DEVELOPMENT REVIEW BOARD
SUPPLEMENTAL SUBMITTAL

PROJECT NO. PR-2019-002277
Application No. SI-2019-00246

SUBMITTAL DESCRIPTION: DRB Site Plan Resubmittal.

**RE: Adagio Apartments
PR-2019-002277**

A-301A

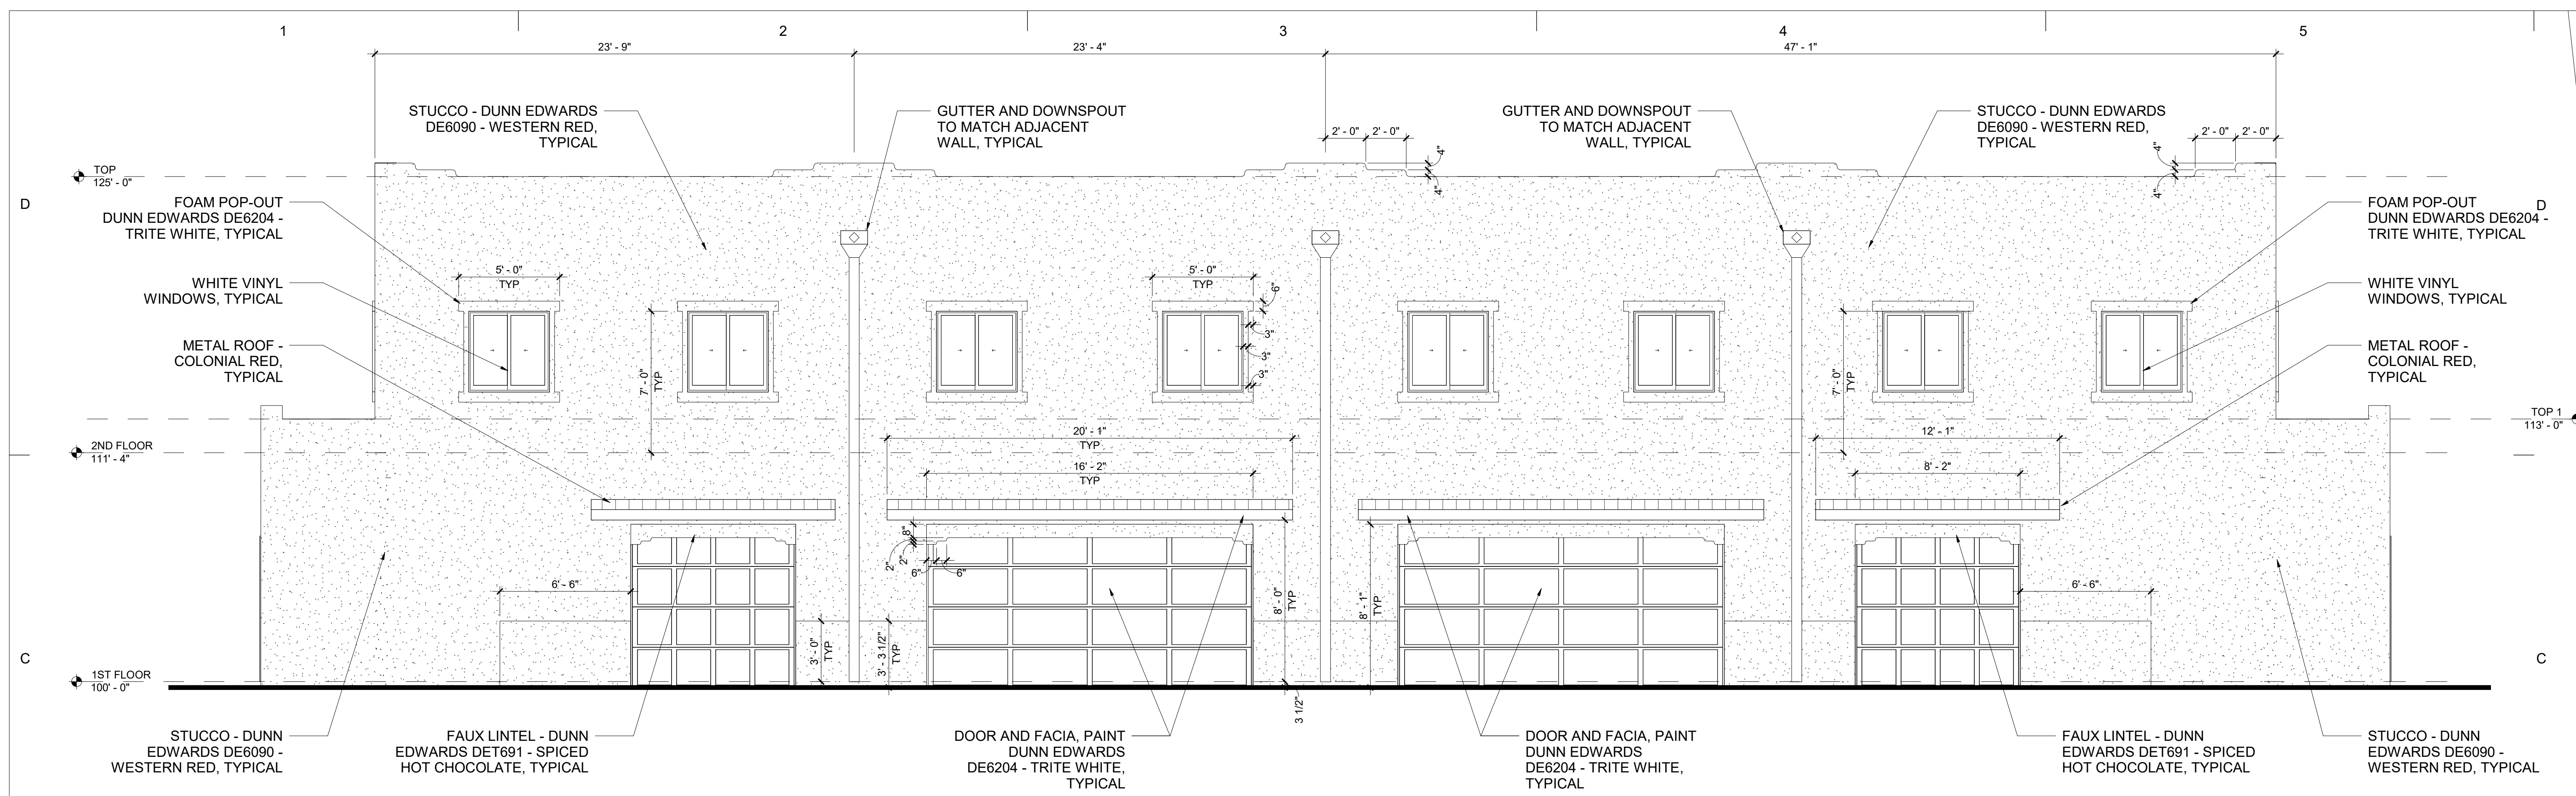
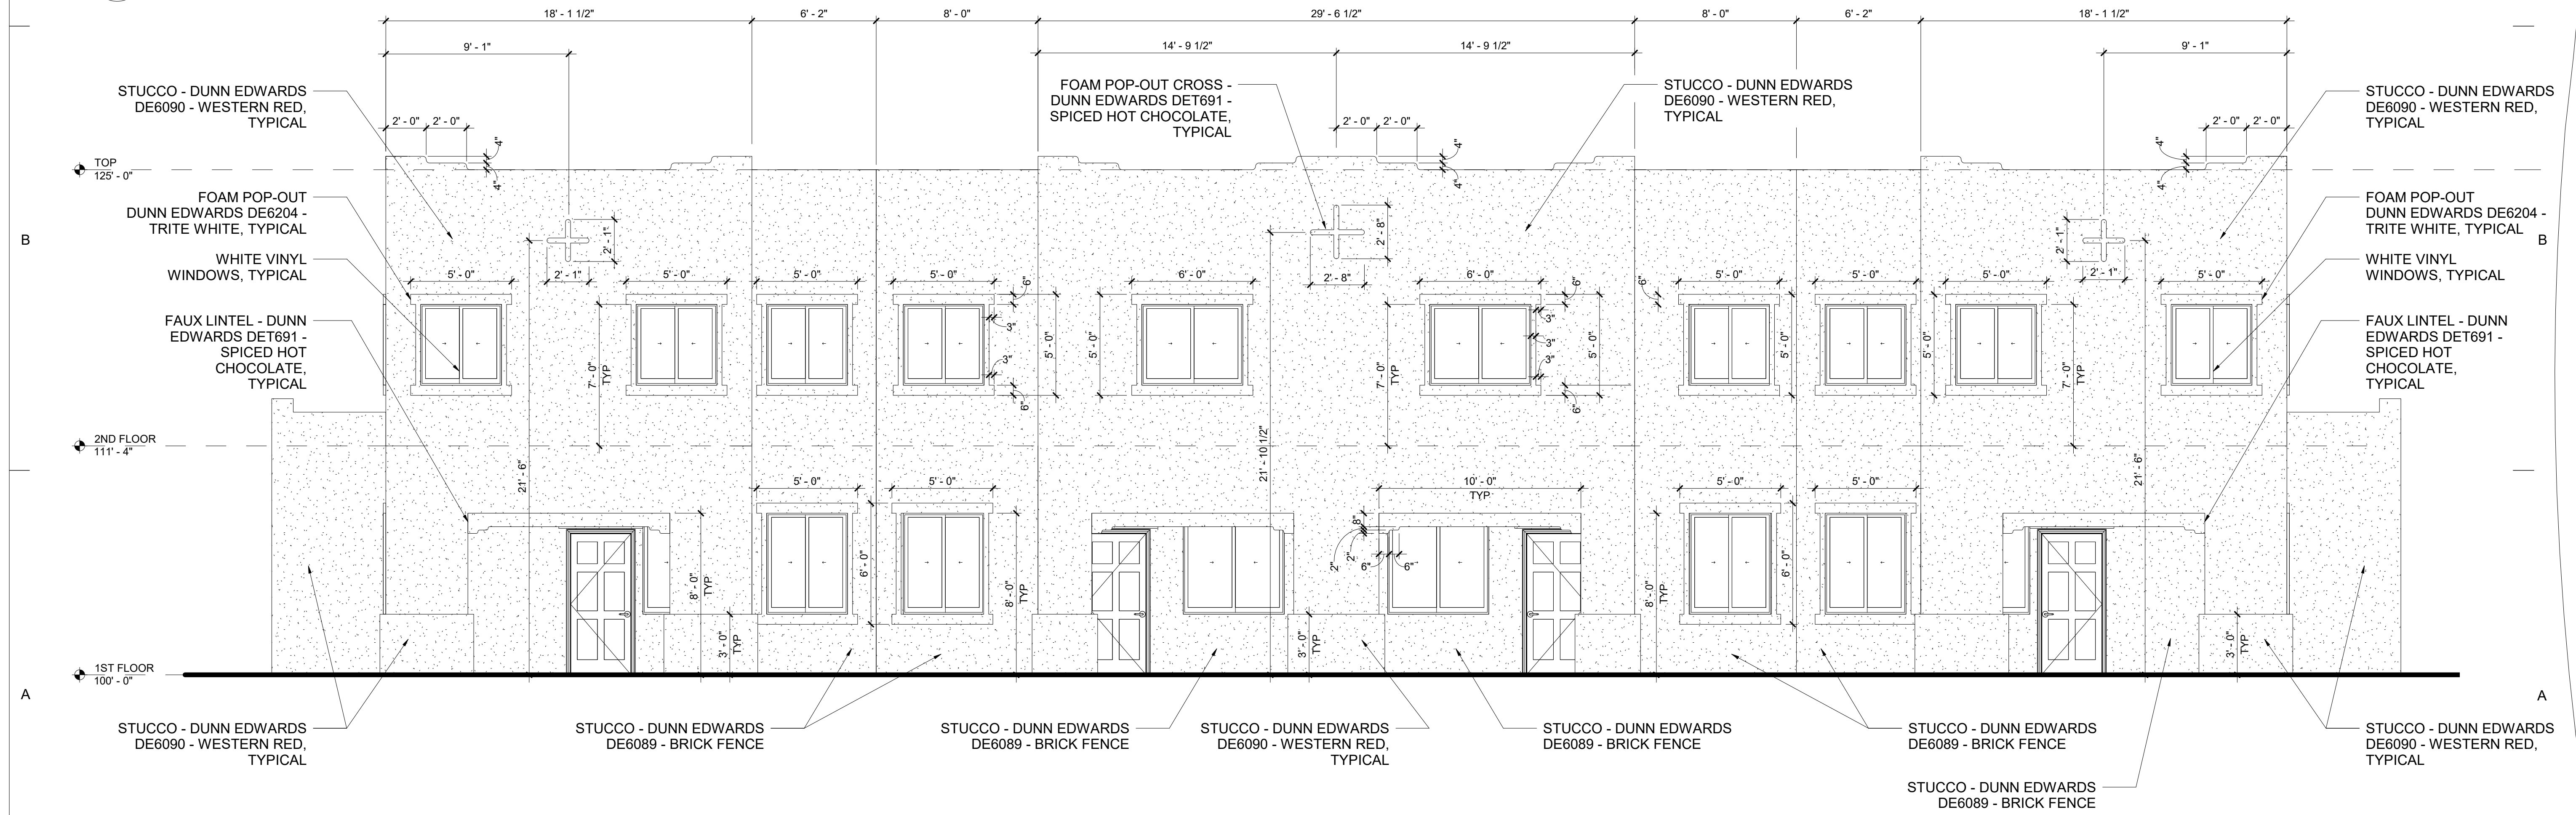
- / The townhomes shall have a color palette consistent with the depiction on the color elevations included in the October 20 supplemental submittal from the applicant.

- o *Response: Revised architectural elevations attached provides color labels consistent with the rendering provided.*
- / All Site Plan sheets must be sealed and signed by a design professional licensed in the State of New Mexico. The Landscape Plan must be sealed and signed by a Landscape Architect licensed in the State of New Mexico.
